Safety Recall for the Enforcer

The swivel eye on some Enforcers may not be secure and in certain conditions might unscrew. This was discovered due to an incident that occurred. This recall is to improve the security of the swivel eye and to issue new user instructions specifying that the Enforcer swiveling action is for orientation, not high speed or multiple rotations.

Identify serial number & manufacturing date on your Enforcer

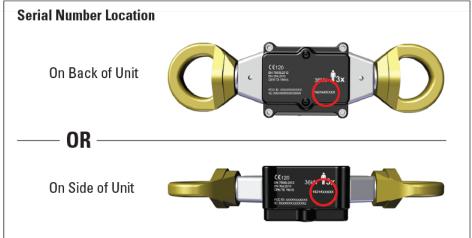
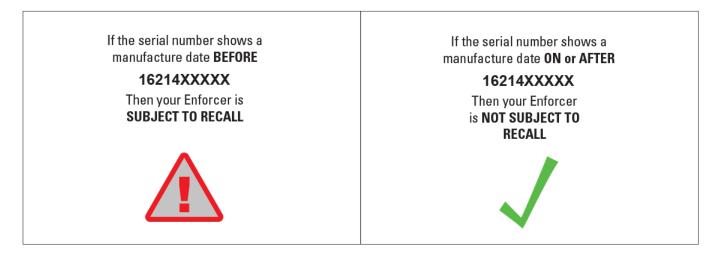
Enforcer units subject to recall used the epoxy/setscrew combination, which includes all units manufactured prior to August 2nd, 2016.

Inspect the 10 digit serial number on your device to determine whether your Enforcer is subject to recall. As shown below, the first two digits of the number refer to the year of manufacture. The three digits following the year of manufacture refer to the day of manufacture during the year. All units indicating a manufacture date prior to 16214XXXXX (manufactured in 2016 on the 214th day of the year) are subject to recall. All units produced ON or AFTER this date are NOT subject to recall. The serial number is laser engraved on the side or back of the device.

You can still use your Enforcer if:

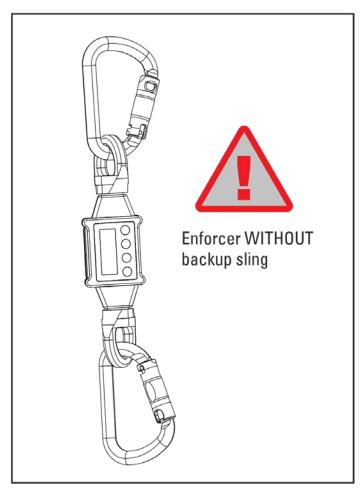
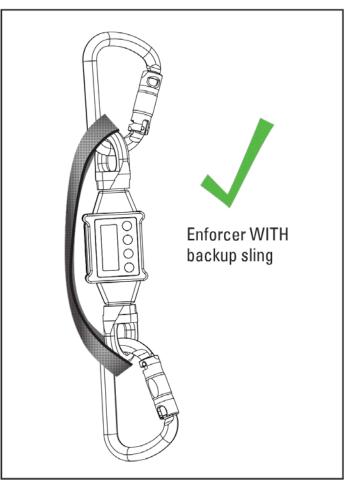
It is mandatory that you send your Enforcer in for the safety modifications as soon as possible. However, you can temporarily use it before sending it if you install a backup. Users are allowed to attach a PPE rated sling with MBS of 22 kN and a maximum of 25 cm (10 in) in length to the carabiners on either side of the Enforcer.

You must also: 1) inspect before and after each use, paying attention to making sure the swivel bolts are not loose, and 2) Do not use for high-speed or multiple rotations. Use for orientation only. 3) Do not use with steel cable. If you have any question of concerns, do not use it.
